Comments Received during the Public Review Period on the Inventory of U.S. Greenhouse Gas Emissions and Sinks: 1990-2011

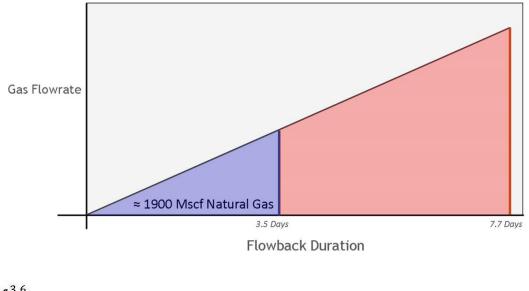
The line represents the relationship between the instantaneous natural gas flowrate, y, at the given time, x.

Then, knowing the rate of the increase in production rate for the average well, A, and setting x at 3.5 days, (the timeframe for those wells that are vented or flared) the area under that curve, which represents the total potential emissions from wells that do not use reduced emission completion equipment, can be estimated.

$$\int_{0}^{3.6} 303.592x \, dx = 303.592(1/2)(3.6^2) = 1859 \approx 1900 \, Mscf/completion$$

Figure 1 EPA's Analysis to Determine Methane Emissions

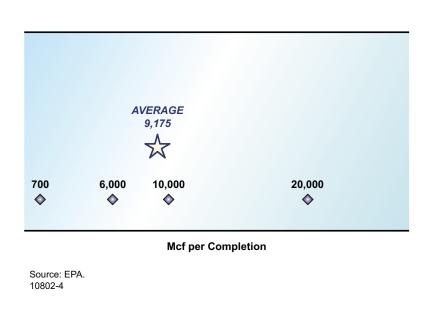
- "The final Natural Gas STAR presentation with adequate data to determine an average emission rate also presented the total flowback and total completions and recompletions. Because of the high variability and uncertainty associated with different completion flowbacks in the gas industry, this was rounded to the nearest 10,000 Mcf—20,000 Mcf/completion" [emphasis added]).** This data point is based on 1,064 wells completed from 2002 through 2006 in the Piceance Basin.
- "This analysis takes the simple average of these completion flowbacks for the unconventional well completion emission factor: **9,175 Mcf/completion**" [emphasis added] (see Figure 1).***

To summarize the math, the final emissions factor of 9,175 Mcf per completion that is assumed to apply to all unconventional wells completed in the United States was calculated as the simple average of four (unaudited) data points. EPA rounded each data point to the nearest hundred, thousand, or ten thousand Mcf as a way of handling the "high variability and uncertainty" in the industry. These four data points represent very different sample sizes (from three to thousands) and underlying data quality. A simple average of these points does not provide a rigorous estimate of industry emissions.

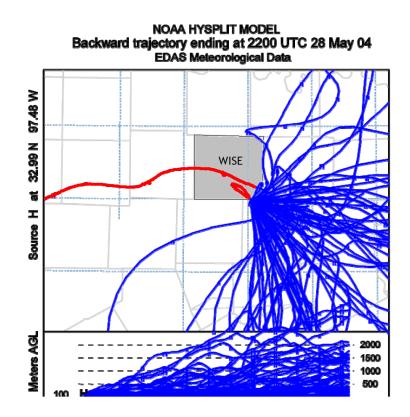
Concern 3: We do not know the results from other monitors downstream of the prevailing wind from Wise County. If the EPA Region 6 wanted to justify Wise County as a contributor of ozone, why did they not provide results from more representative monitors? As the Texas Commission of Environmental Quality described, the presented data seems to be "cherry-picked".

The below figure contained in this handout shows a composite of all modeling results done by EPA Region 6, with the two Wise County events highlighted in red.

Figure 1. Distribution of Mean Methane Gas per Completion (Mcf)

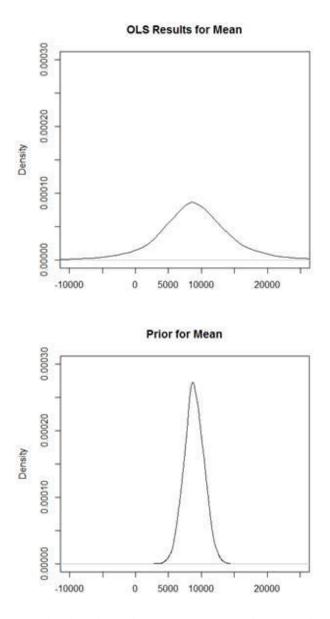
In Figure 1, both the prior and OLS distribution for mean methane emissions are displayed. Both distributions are centered about the mean of 8,900. The spread of possible outcomes for the two distributions are very different, however. The OLS data-driven results have a very wide spread about the mean with a significant portion of that distribution's support falling on the negative part of the real line. In contrast, the prior has a very tight fit with most of its support restricted to a small range about the mean. Given that we have such a tight prior and such a limited amount of data (just 4 observations), we would expect that the prior rather than the data would be the defining influence on the posterior.
